August 1, 2007 BZA

REQUEST ANALYSIS  
AND  
RECOMMENDATION

07AN0364

REQUEST: A Variance to use a parcel of land which fronts a dedicated but unimproved public road for dwelling purposes in a Residential (R-15) District.

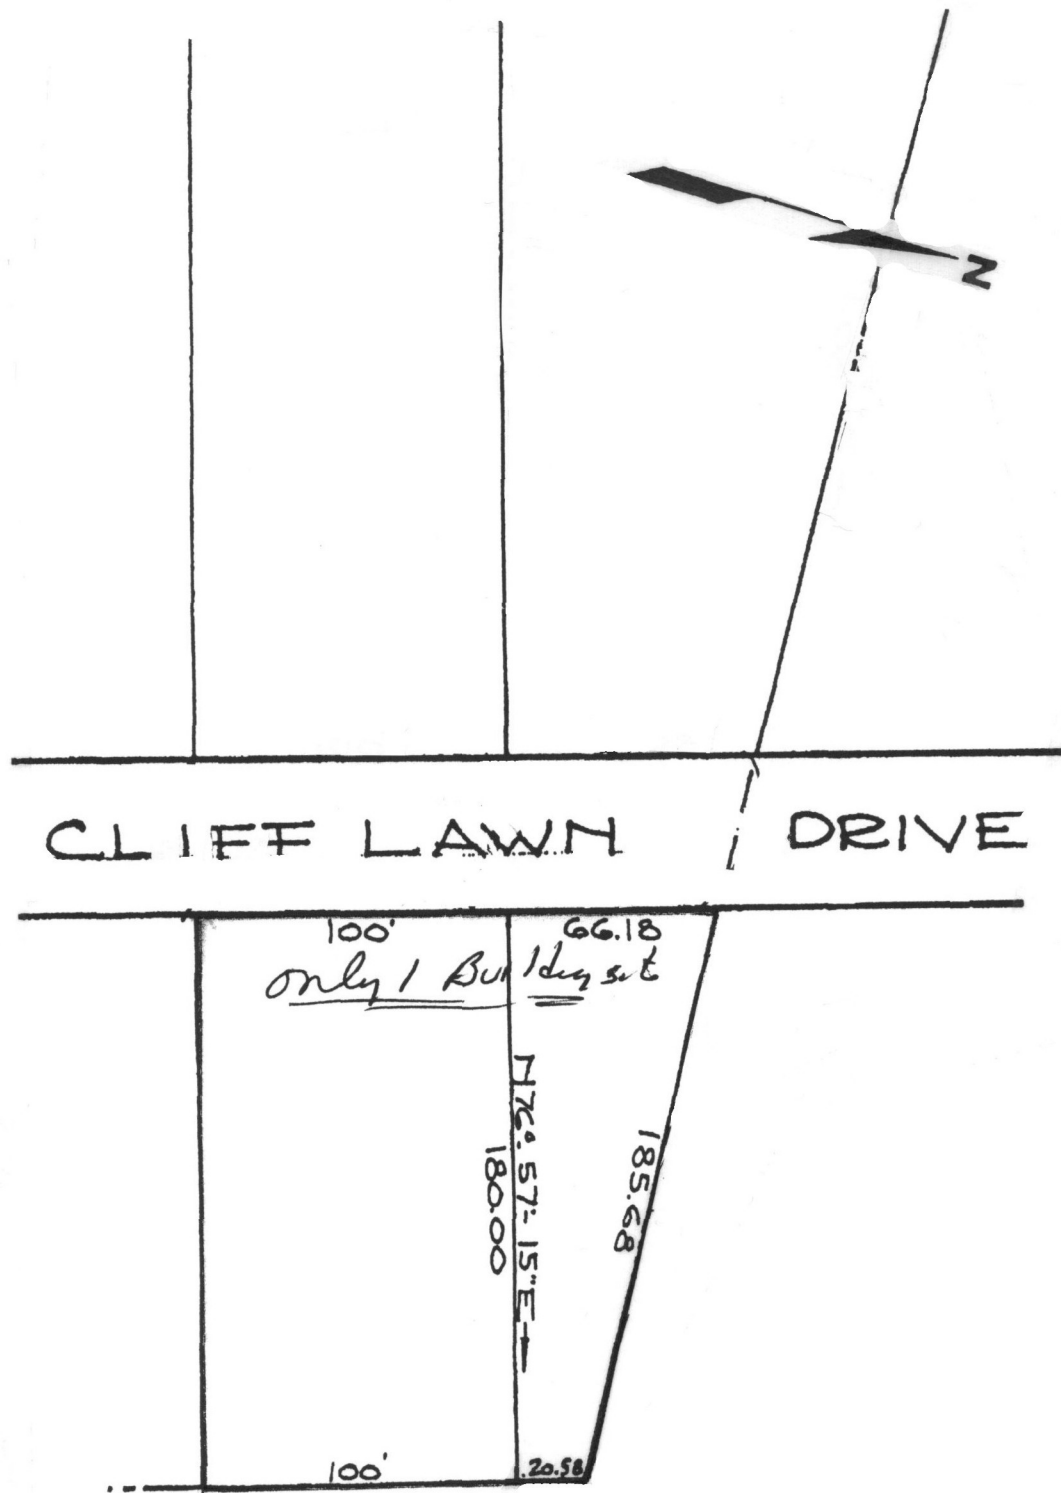
The applicant requests a Variance to use a parcel of land which fronts on a dedicated, but unimproved, public road for dwelling purposes. The access to the dwelling will be over a fifty (50) foot dedicated road from Point A to Point B (option 1 or 2), as shown on the attached map.

1. Prior to approval of a building permit, the applicant shall provide a copy of the approved license agreement with the County to use the dedicated and unimproved County right of way from Point A to Point B (option 1 or 2), as shown on the plat attached to the staff report. (P)

2. A fifteen (15) foot wide roadway shall be constructed and maintained to all weather standards from Point A to Point B in accordance with the following standards:
